ADDENDUM

Date Issued:	Feb 21, 2024
Project:	Intermountain Health Intermountain Kidney Services – West Valley Dialysis 2750 South 5600 West West Valley City, UT 84120
Addendum Number:	1

Date: 2/20/24
Project No: 22249
Project: IKS West Valley Dialysis
Revision: Addendum #1

Demolition
Floor Plan
Level 1

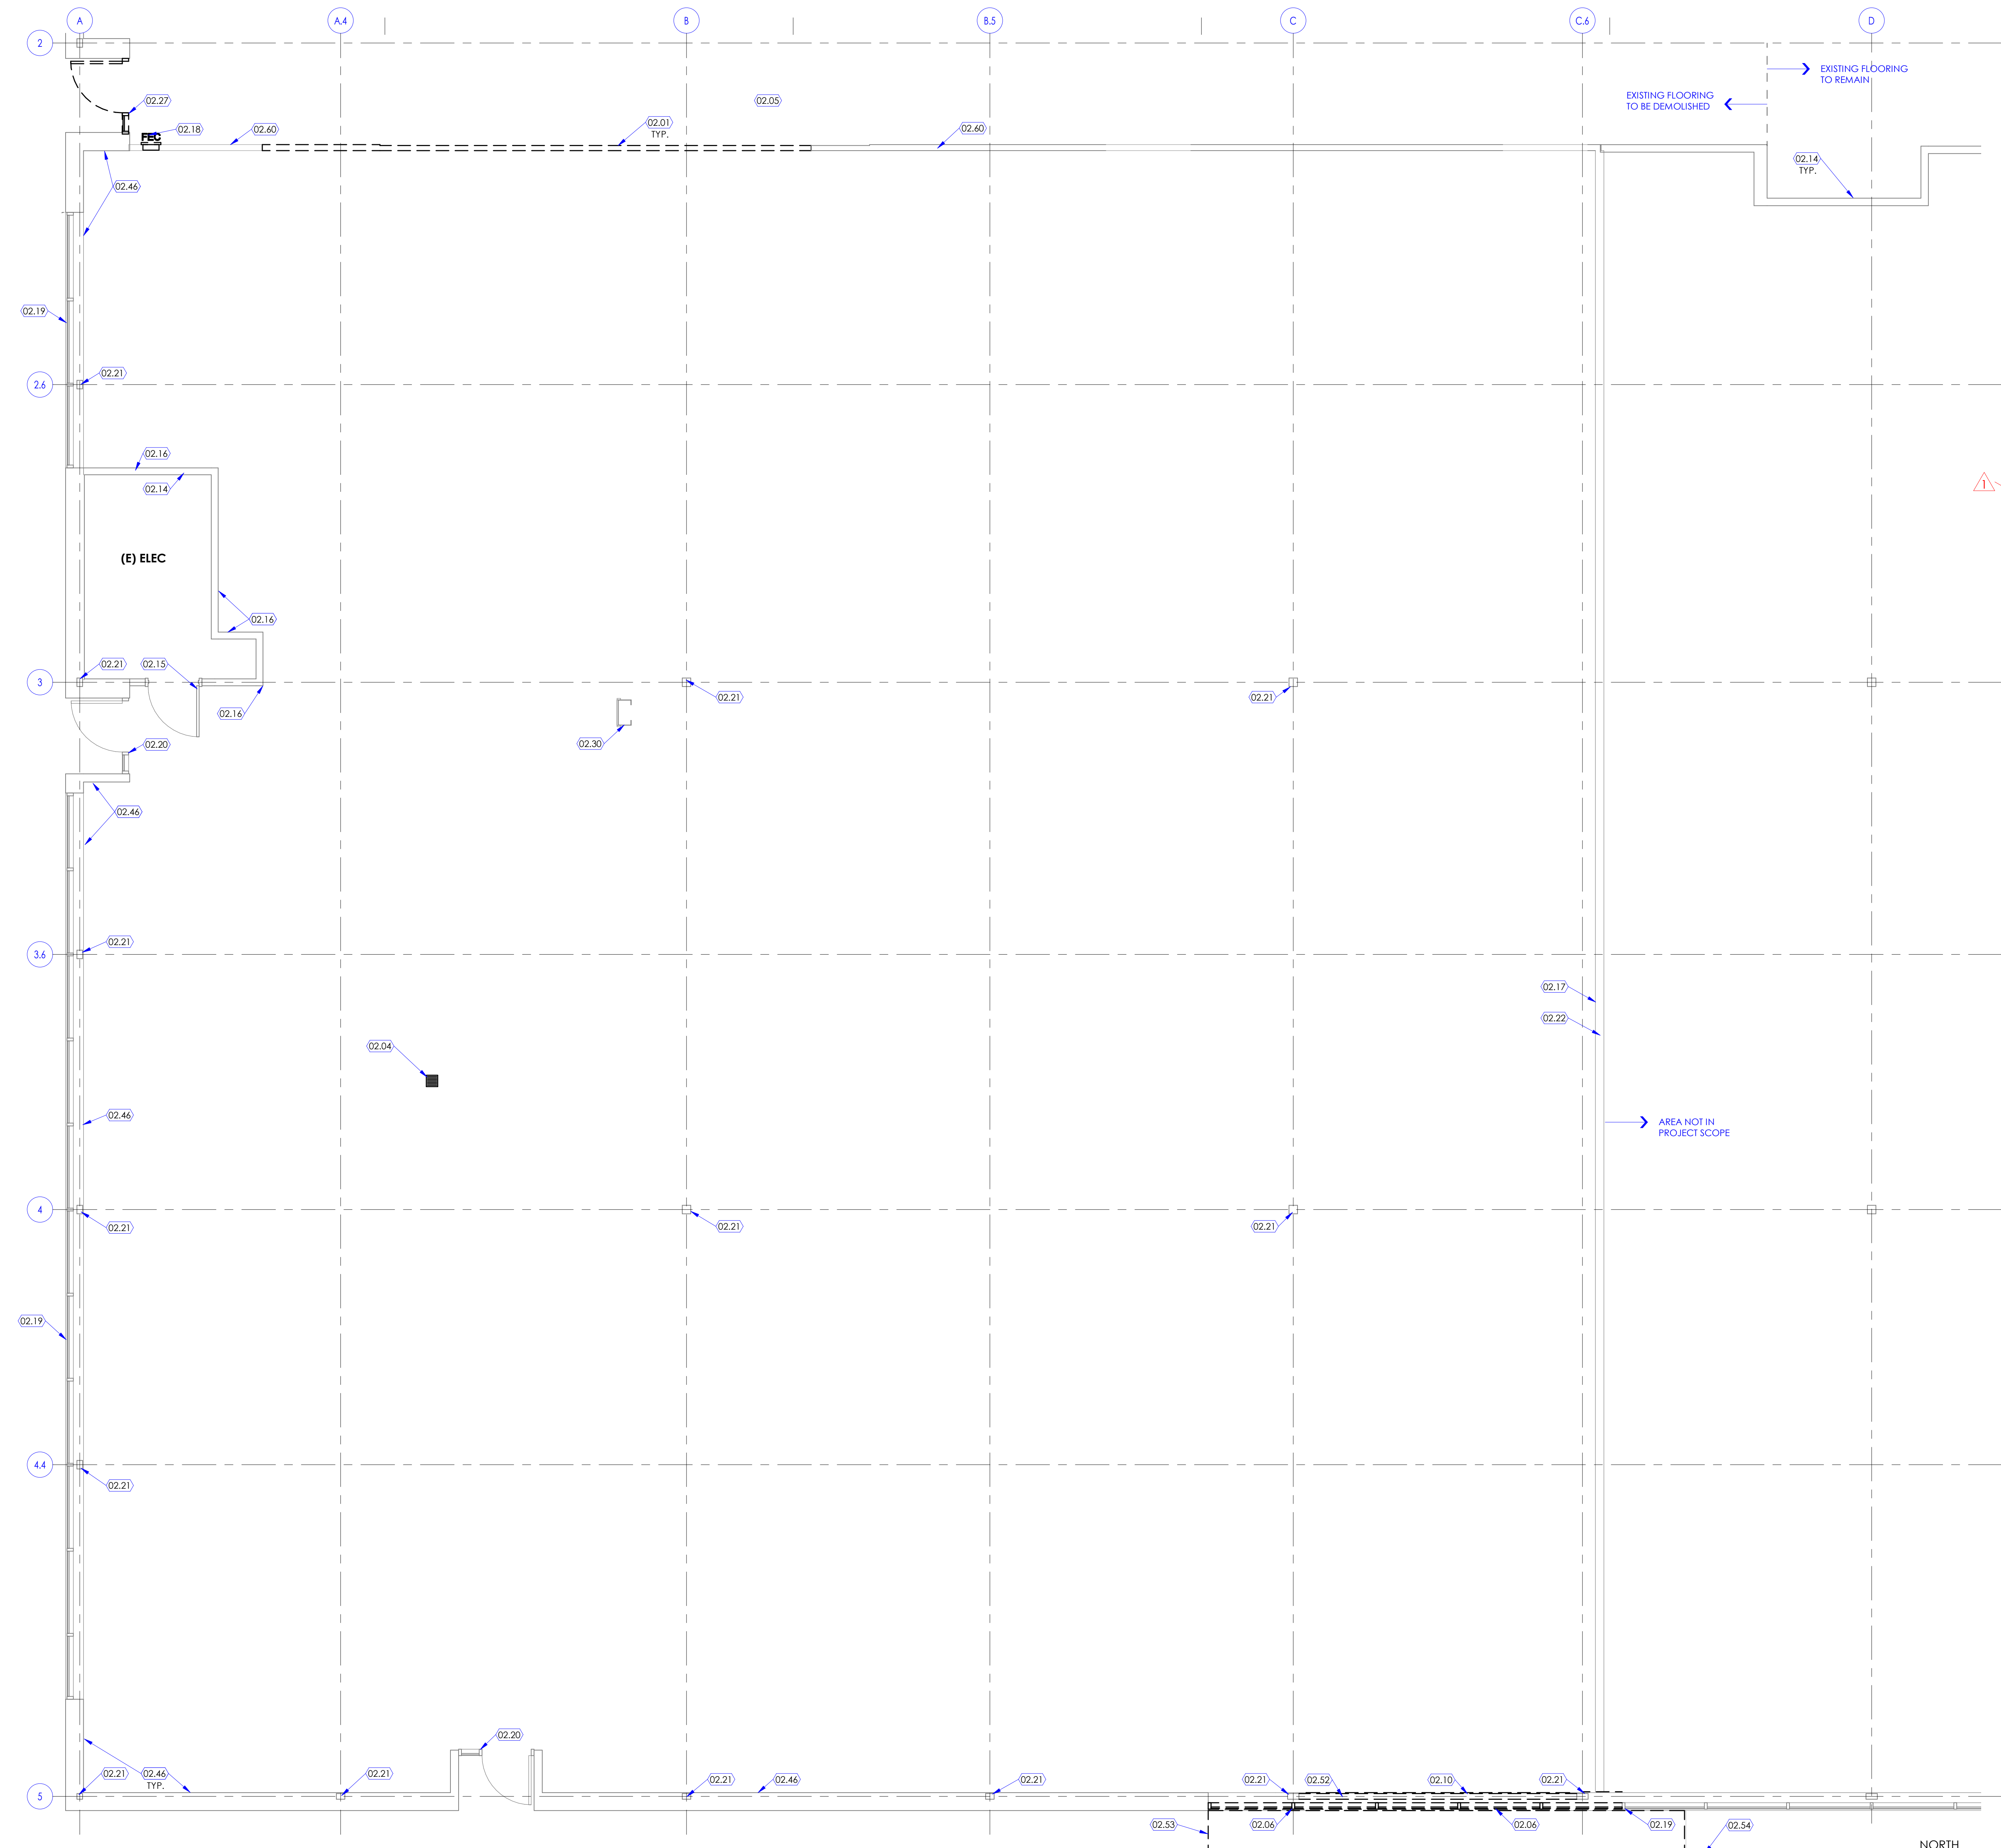
Sheet Number	Drawings
	Architectural Drawings
A110	Clarified extent of slab demolition per questions from bidders. Demolish entire slab on grade. Additional demolition may be required to route electrical conduits from generator to new electrical room
A111	Existing ladder to be removed and stored during slab demolition.
A603A	Clarified tile questions from bidders.
	Mechanical Drawings
	See attached mechanical addendum
	Electrical Drawings
	See attached electrical addendum

- 02.42 REMOVE EXISTING SLAB ON GRADE AS REQUIRED TO ROUTE ELECTRICAL CONDUITS FROM GENERATOR TO NEW ELECTRICAL ROOM. PATCH CONCRETE TO MATCH ADJACENT EXISTING AFTER ALL WORK IS COMPLETE. SEE DETAIL 7/A506A FOR TRENCHING AREAS BETWEEN EXISTING SLABS.
